Response to
Request for Additional Information No. 167, Supplement 2

U. S. EPR Standard Design Certification
AREVA NP Inc.
Docket No. 52-020

**SRP Section: 15.06.05 - Loss of Coolant Accidents Resulting From Spectrum of
Postulated Piping Breaks Within the Reactor Coolant Pressure Boundary**

Figure 15.06.05-30-1—ECCS and EBS Functional Arrangement with RCS Loops

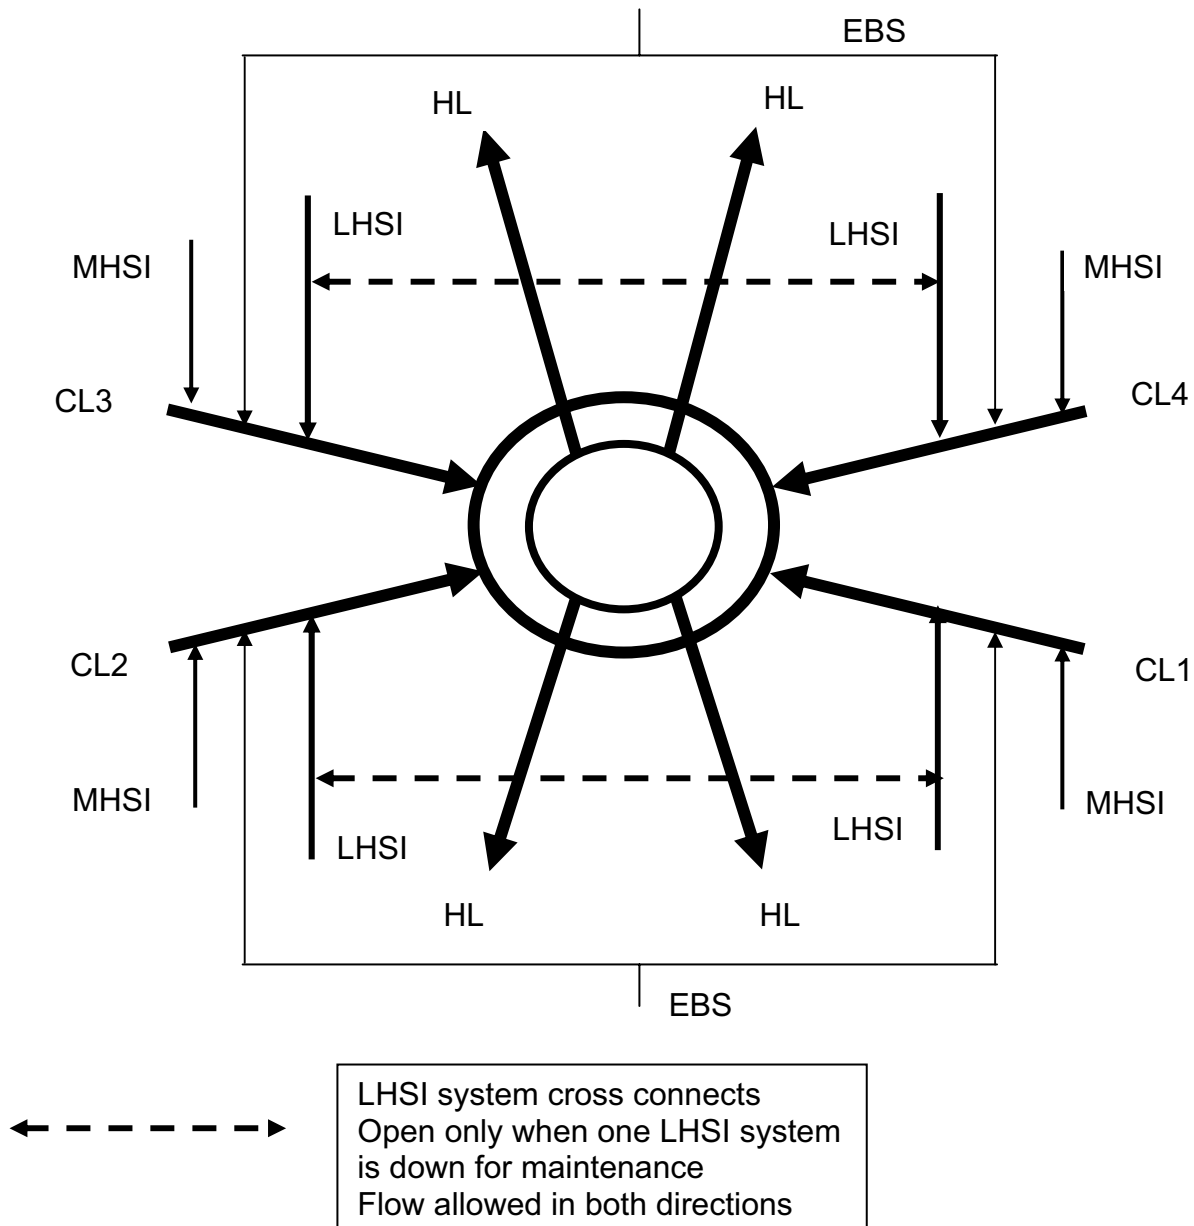
Explain the availability, quantity and distribution of emergency core cooling system (ECCS) flow for each individual loop consistent with the analysis assumptions made. Address the possibility for conditions that deprive a loop from any ECCS injection. If such a possibility exists, address associated effects on the restart of the natural circulation and mixing in the corresponding cold loop.

The U.S. EPR emergency core cooling system (ECCS) is arranged as four independent safety injection trains with the ability to cross-connect the LHSI trains when one LHSI train is inoperable. The EBS has two independent trains, each supplying two cold legs; Figure 15.06.05-30-1 shows the functional arrangement. The design basis for the ECCS includes provision for the single failure of one train and another train out of service for maintenance.

The most severe single failure is one that affects both the MHSI and the LHSI feeding one loop. With any train out for maintenance, both cross-connects are open. The presence and location of a single failure and maintenance creates multiple combinations of ECCS injection capability. The possible injection scenarios are shown in Table 15.06.05-30-2. If a system delivers all its flow to one loop, that loop receives a "1." If the cross-connects are open, the LHSI system will deliver approximately half its flow to each of the two loops, therefore in the table each loop receives a "0.5." Because some of the safety injection (SI) flow will be lost out the break (in loop 4), the "Effective SI" is the quantity of SI that participates in refilling the RCS. The result is that there are, within the design basis, scenarios for which one or two loops will not receive SI flow. These loops will receive backfill from the reactor vessel with water at the downcomer boron concentration as the plant refills. There is also the possibility, within the plant capabilities, that the emergency operating procedures will direct manual initiation of the EBS system for all the loops, including those that are not receiving SI. The accumulators inject into all four cold legs passively as the RCS pressure permits.

Figure 15.06.05-31-1—Steam Generator Secondary Pressure for 1.5 inch Break

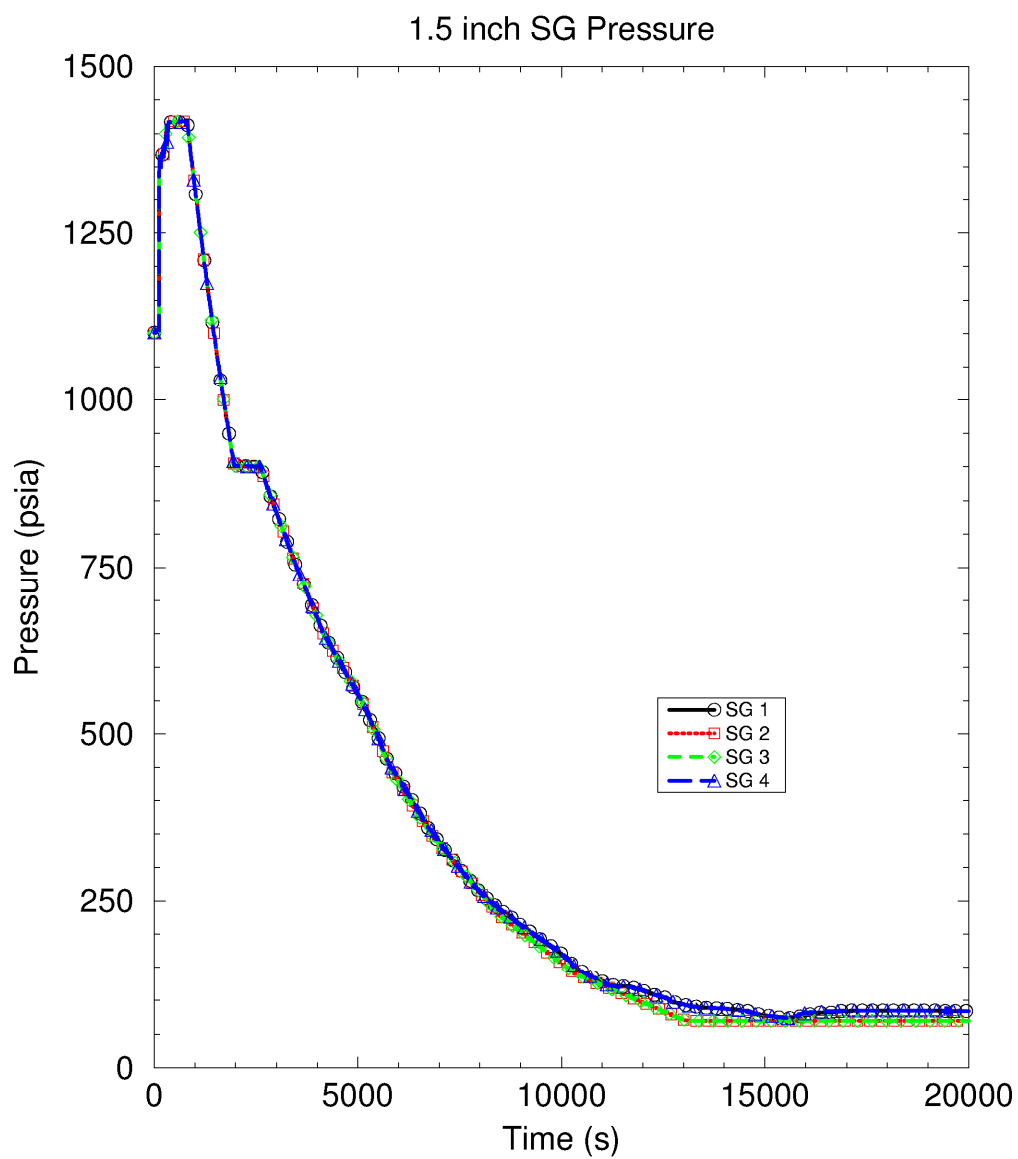
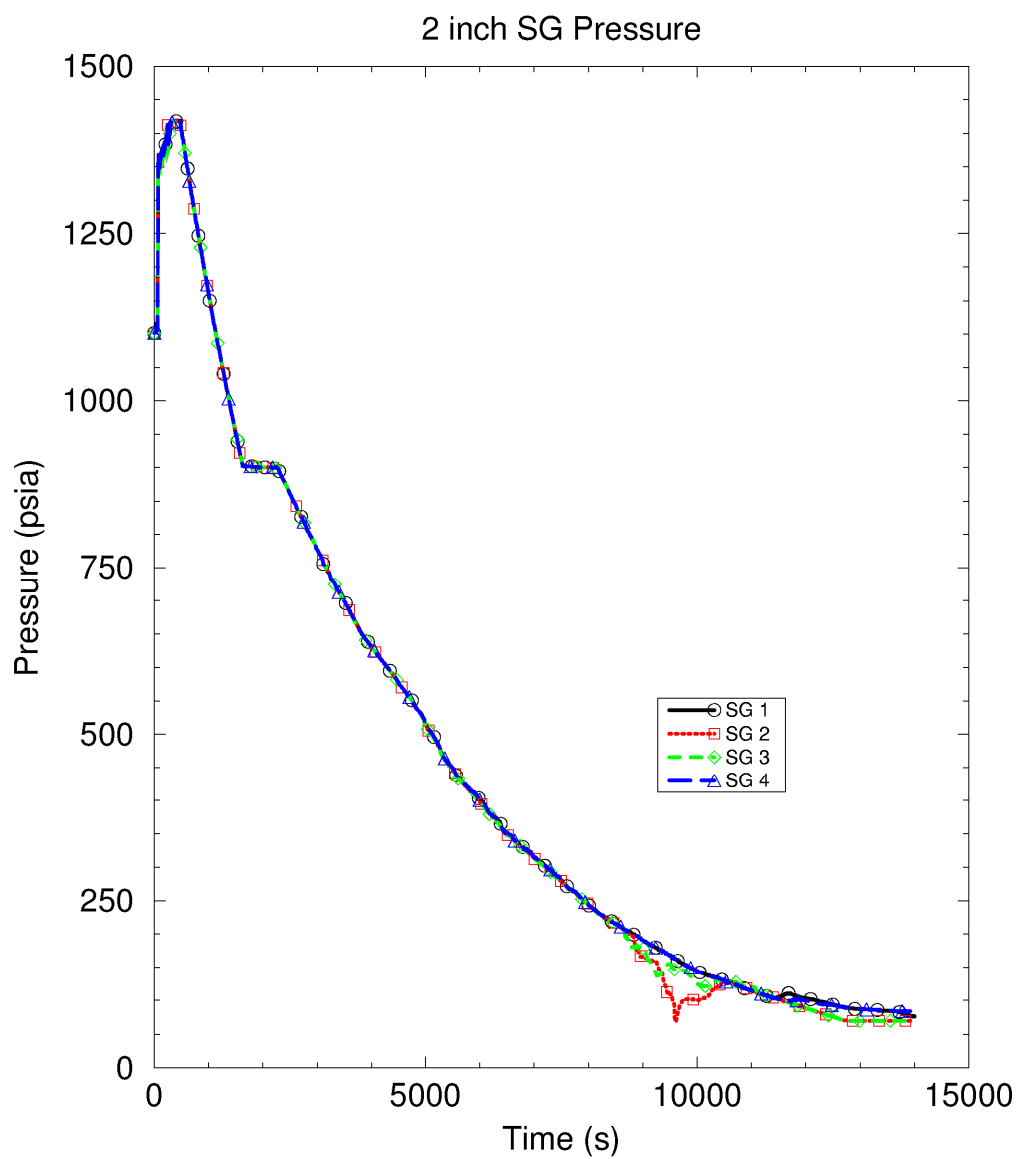
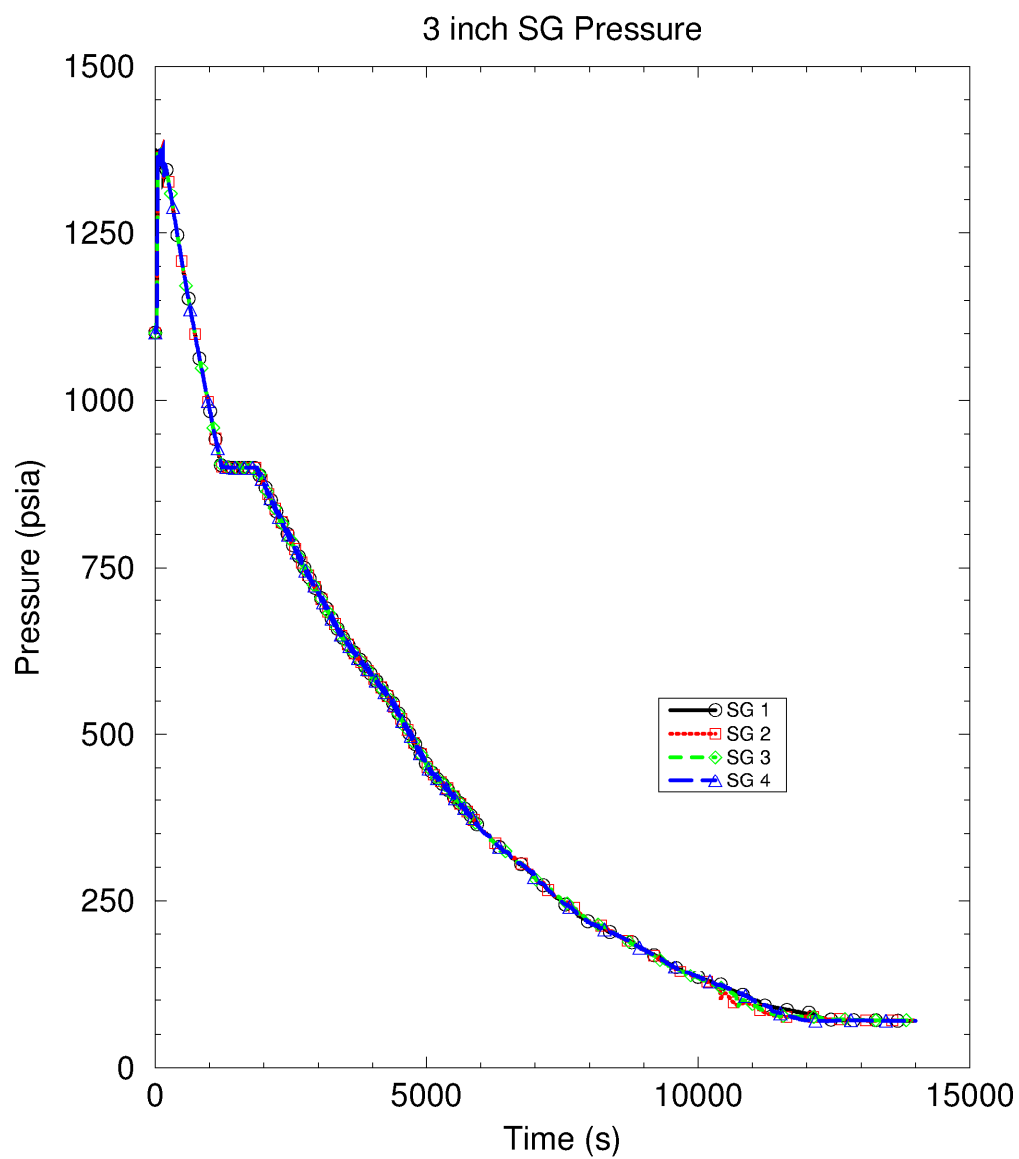
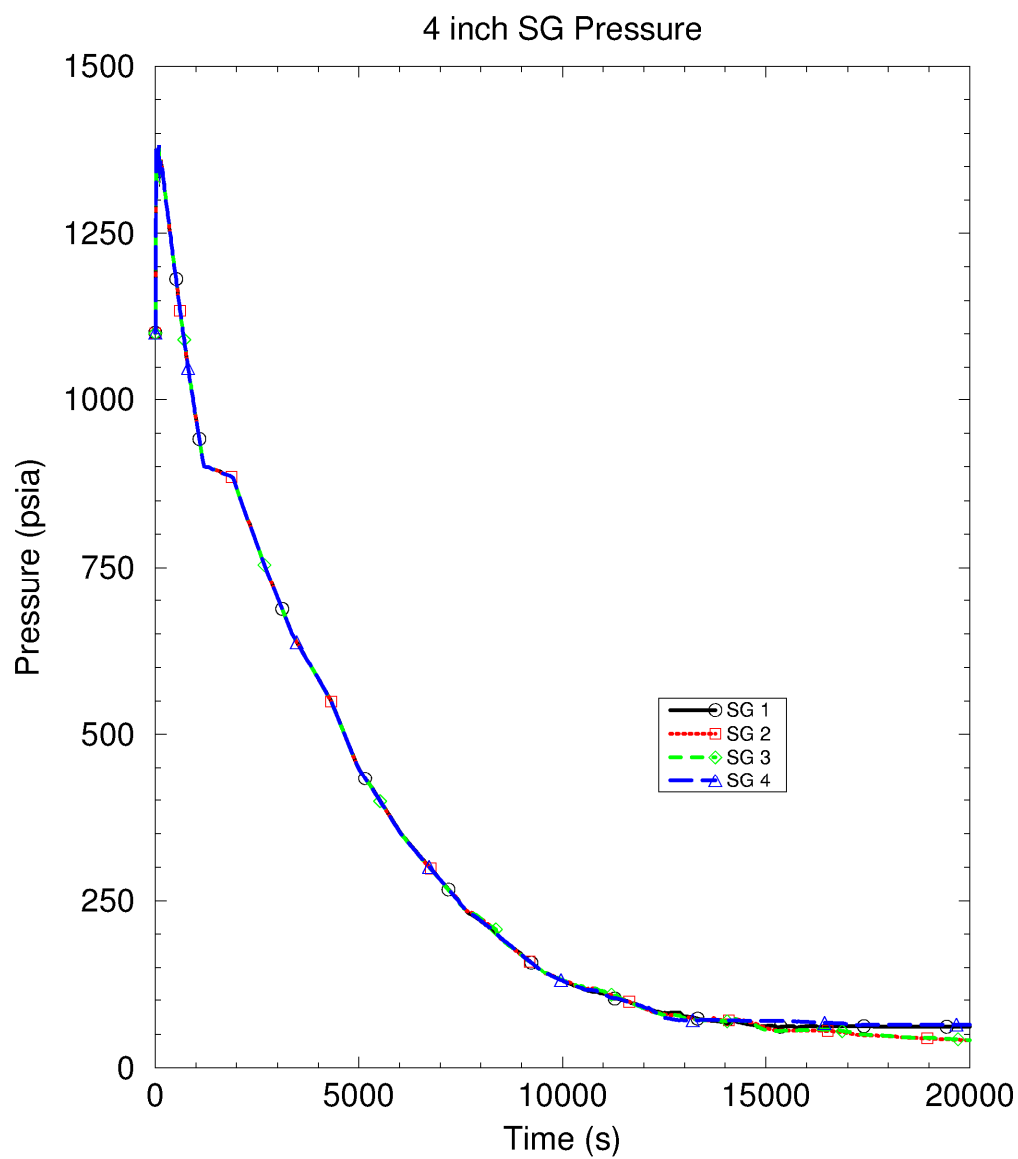
Describe the SG secondary response in terms of pressure, temperature and liquid inventory conditions for each individual SG consistent with the analysis assumptions made, including EFW availability and depressurization considerations.

For the four boron dilution cases analyzed (1.5 inch – 4 inch breaks), the SG pressures are provided in Figures 15.06.05-31-1 through 15.06.05-31-4. The analysis of the 6 inch break was run to demonstrate the prevention of boron precipitation. For this 6 inch break, the continued cooldown of the SGs does not depressurize them below the reactor coolant system (RCS) pressure until approximately 12,000 seconds into the event. Thus, the SG pressures for this accident are not included.

The secondary side is near saturated conditions. Given the pressure, the boiling temperature is known for the secondary side of the SGs. The automatic partial cooldown that brings the SG pressure to 870 psia occurs over the first 1200 seconds. At 1800 seconds the plant operator initiates the continued SG cooldown at 90°F/hr. In the 4 inch SBLOCA case the SG pressure curve is not flat from 1200 seconds to 1800 seconds because the primary depressurization is more rapid than the secondary, and the primary side coolant passing through the SGs is cooling the secondary side. In the 2 inch break, there is a temporary pressure reduction in SG 2 between 9000 and 10,000 seconds due to backflow of cold safety injection water into the SG tube region prior to the start of circulation.
